Town of Arlington, MA Redevelopment Board

Agenda & Meeting Notice November 7, 2022

3. Public Hearing Docket #3717 80 Broadway

Public Hearing Docket #3722 141 Massachusetts Avenue

COVER SHEET

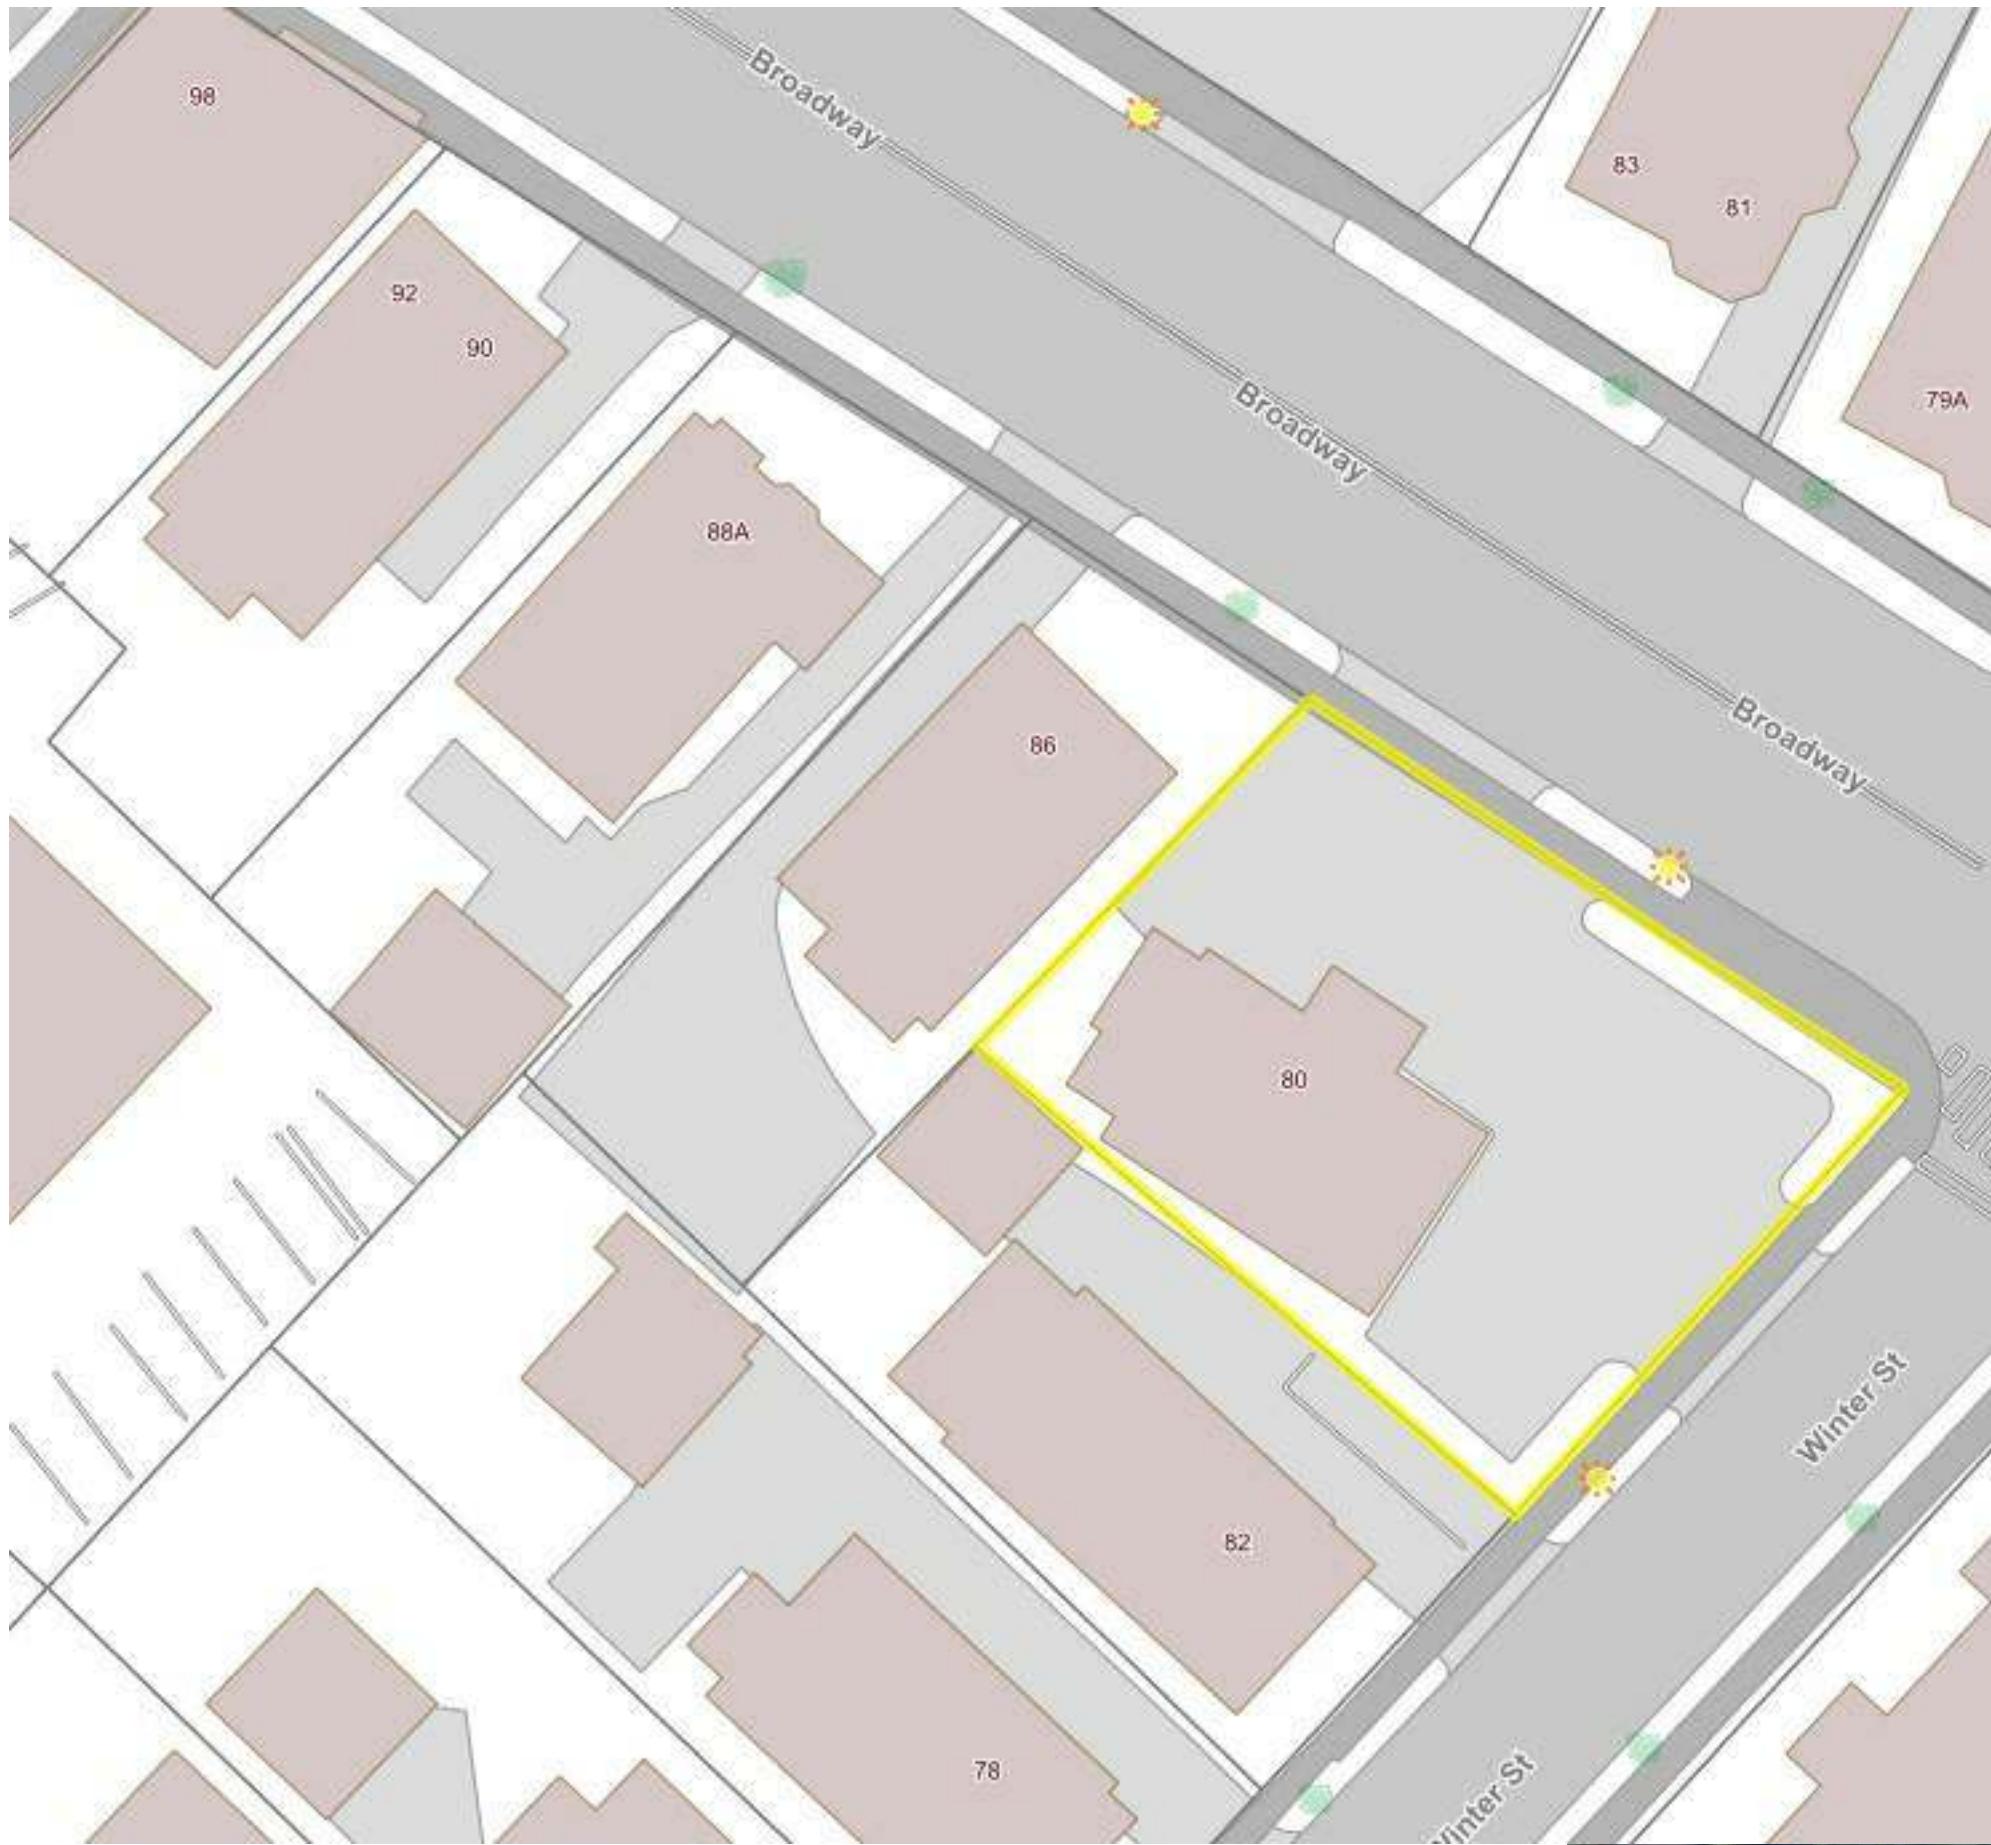
1. Is the applicant asking the ARB to grant a variance on the front yard setbacks? On drawing A0, the applicant correctly notes that bylaw 5.3.8 requires that corner lots have front yard setbacks that match the adjoining R2 lots, which is 20' on both the Broadway and Winter street frontages. The plans however show zero setback on Broadway and only 2' on Winter St.

ROOF AREA	2917 SQFT
SOLAR PANEL ROOF AREA	1657 SQFT

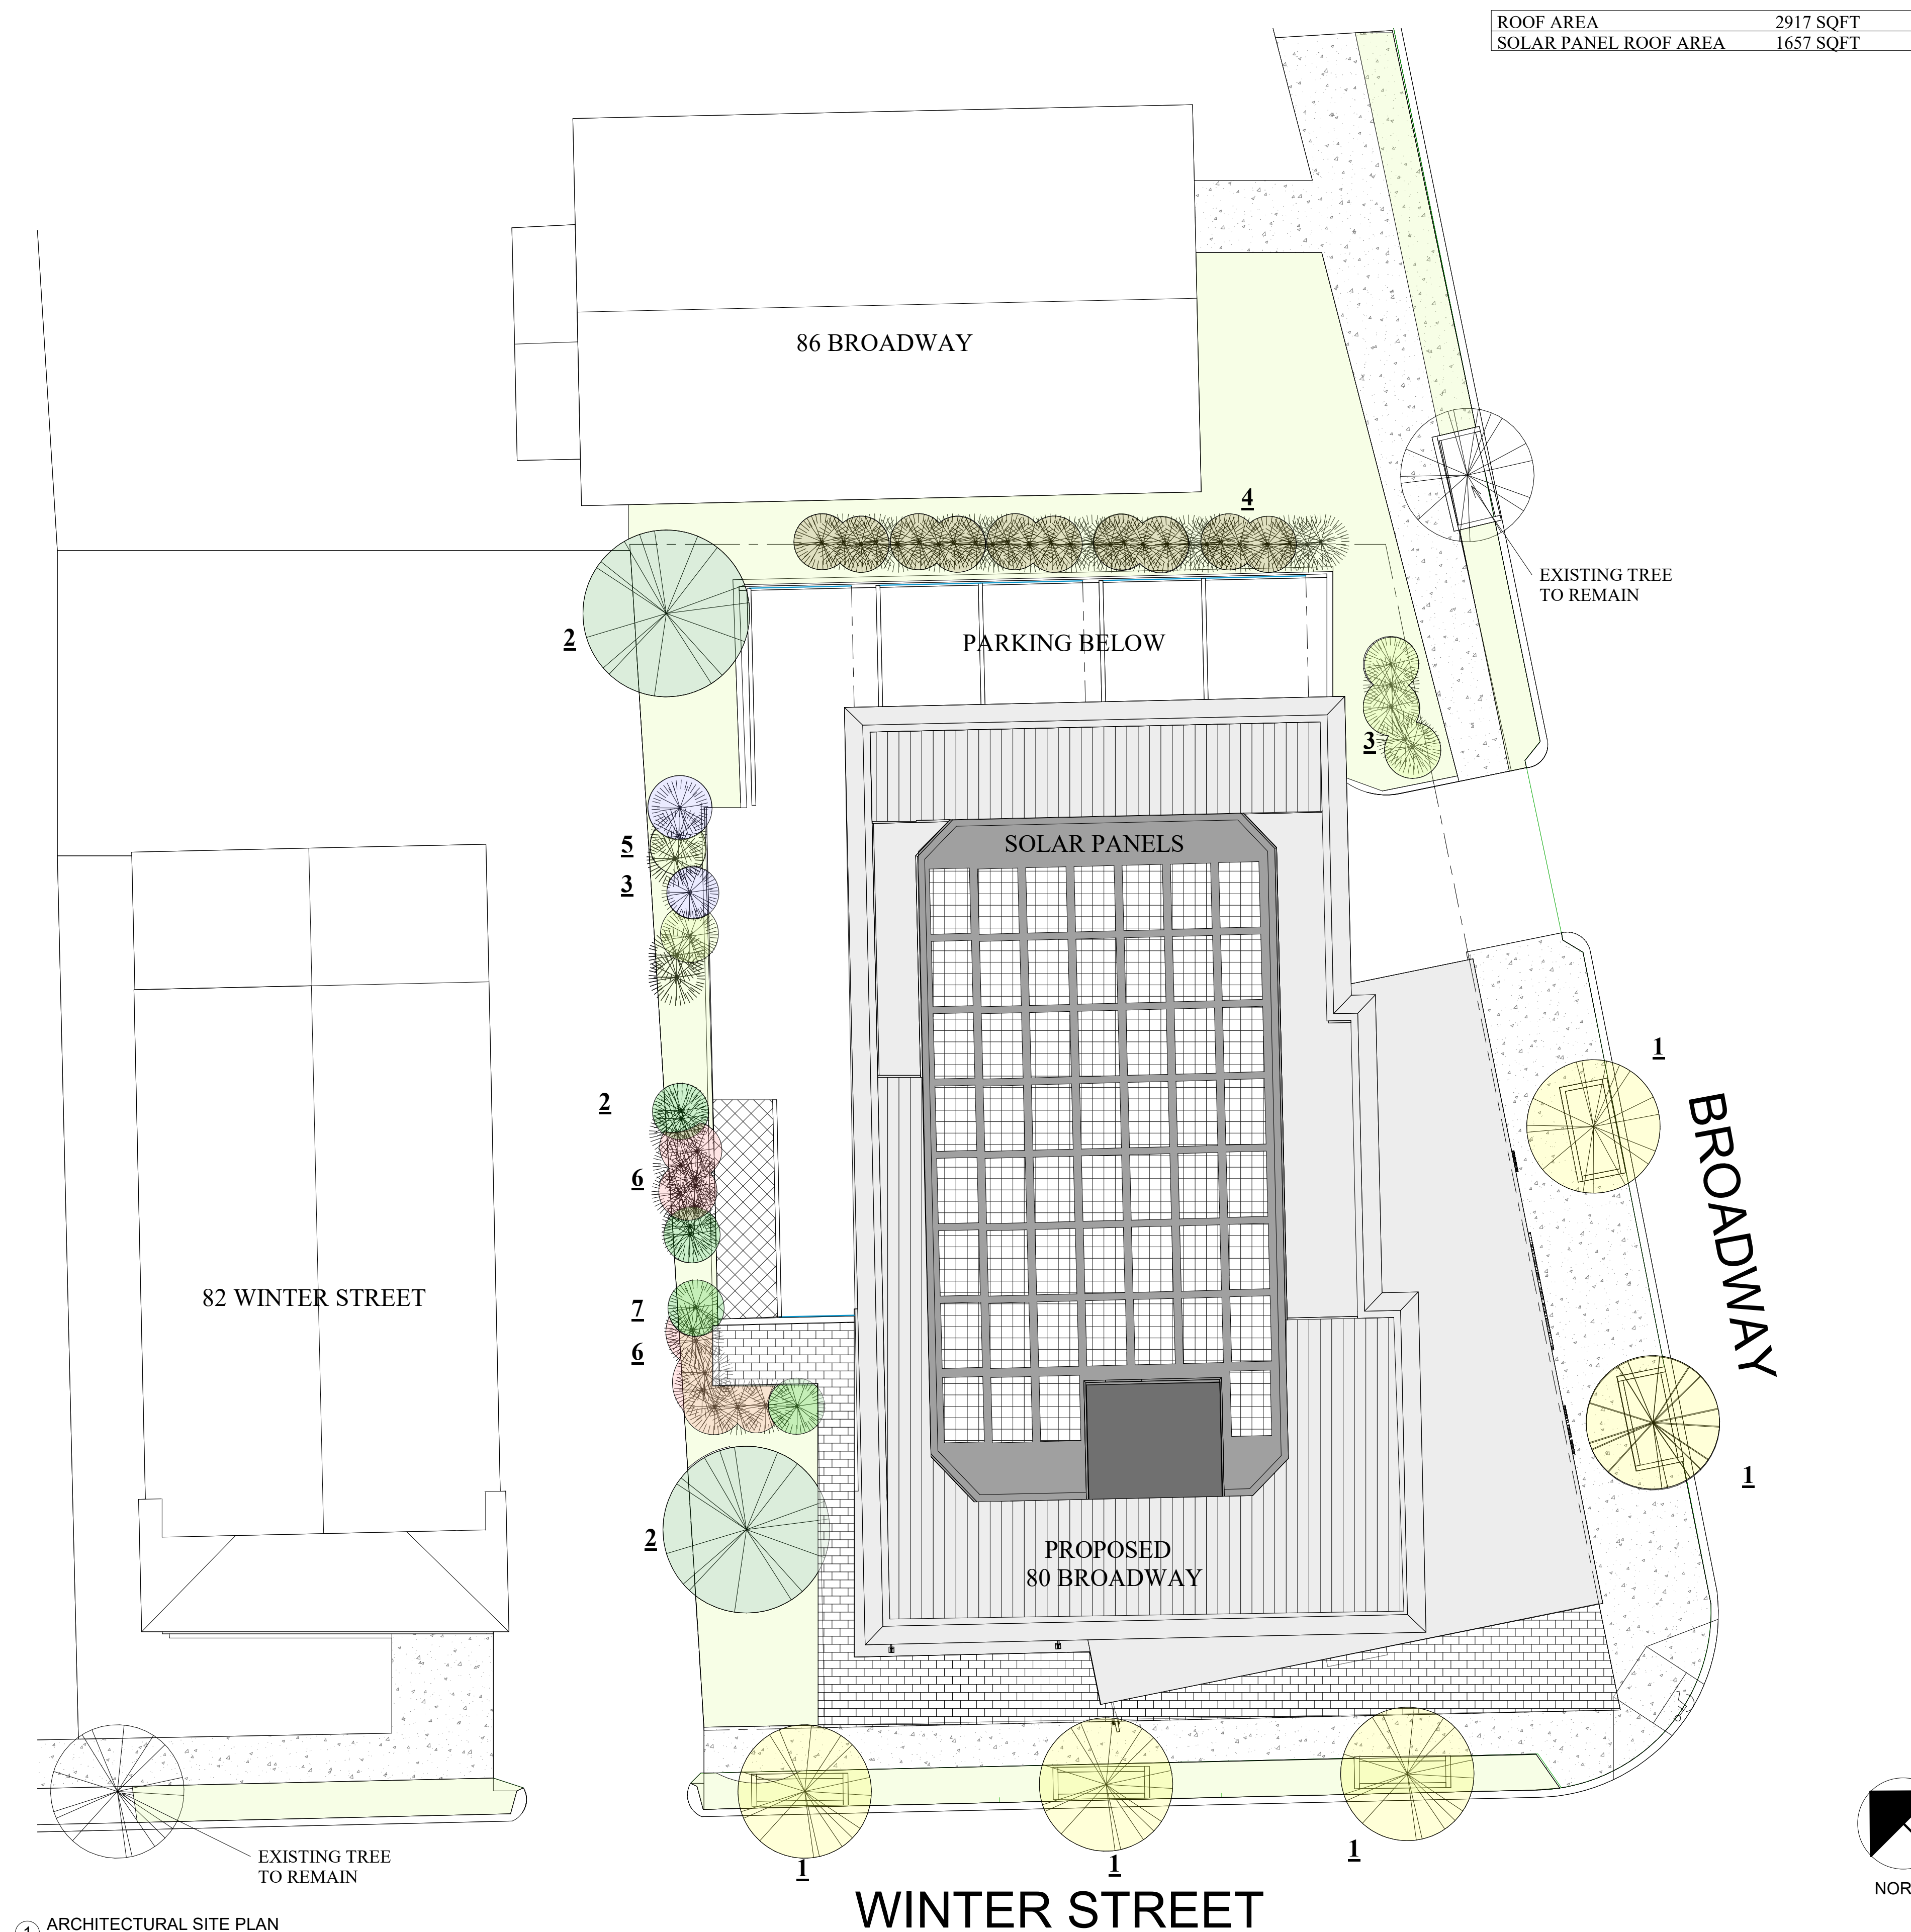
7. Could the applicant explain the calculations of the ratio of solar panel area to total roof area? In particular, the figure of 2917 sf of total roof area appears to be significantly underestimated.
